## **SYDNEY CENTRAL CITY PLANNING PANEL**

### **COUNCIL ASSESSMENT REPORT**

| <b>DA Number</b>   | DA/843/2018  |
| <b>Proposed Development</b>  | Demolition, tree removal and construction of a 4 storey Residential Flat Building comprising 22 units over 1 level of basement parking.<br>The application is to be determined by the Sydney Central City Planning Panel.  |

Figure 5: Tree Management Plan (Naturally Trees 2018)

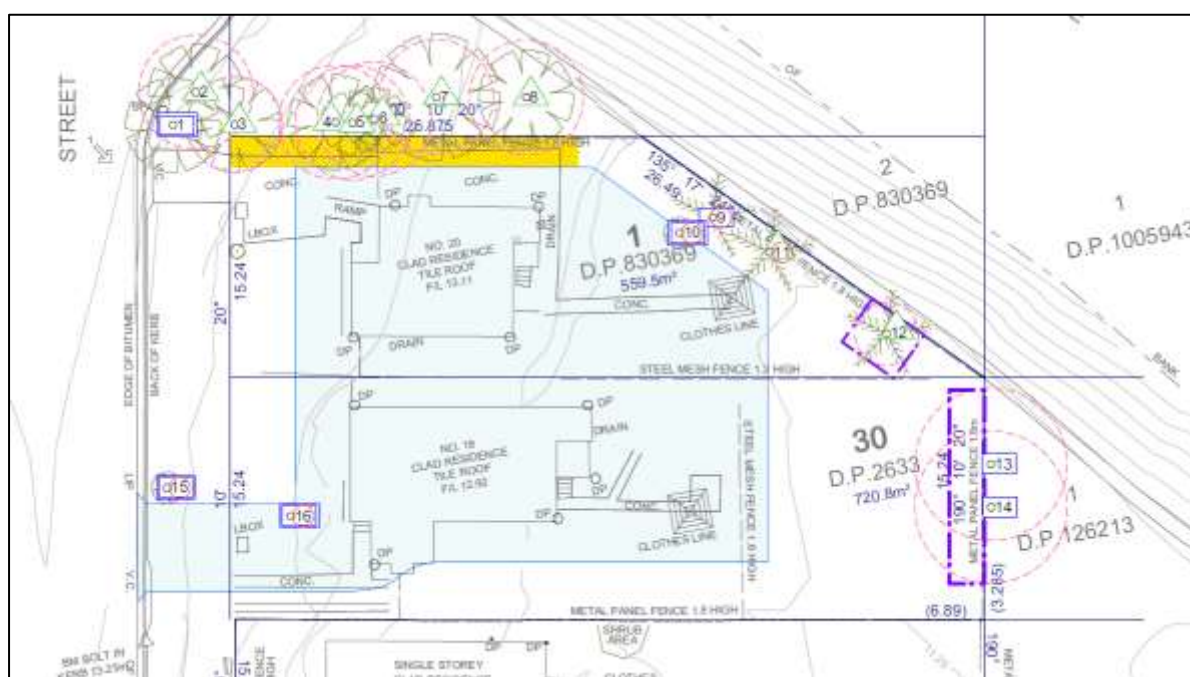
Council's Tree and Landscape Officer supports the removal of these trees subject to the retention and protection of the trees located on the adjoining site.

Subject to conditions for replanting and the protection of the remaining trees on the adjoining site, and replanting of street trees, the application meets the aims of the SEPP.

**Figure 19:** Extract of Section 4 showing exceedance in building height.

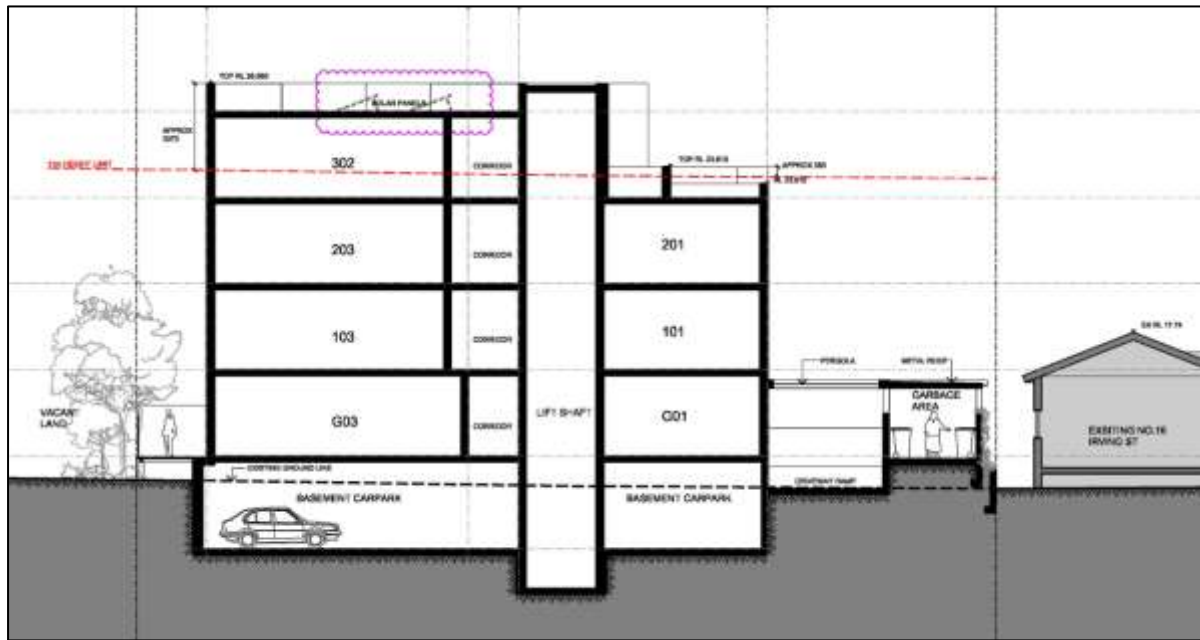
Clause 4.3(2) of the Parramatta LEP 2011 identifies a site on which a building is to be erected shall not exceed 11 metres in height. The application proposes a maximum building height of 15.1 metres, which is a variation of 4.1 metres or 37.3%. See Figure 17, 18, 19 and 20 below:

- The elevation and sections plans in Figures 17, 18, 19 and 20 above, illustrates that the exceedance includes almost the entirety of the fourth floor including external walls, ceiling, and services.

The applicant’s justification relies partially on the topography of the site sloping to the rear resulting in a degree of exceedance. In Council’s view, the topography of the site may account for some of the exceedance in building height, however the extent of the non-compliance still remain even if the site were flat due to the development being a four storey building where the planning controls envision a three storey building.
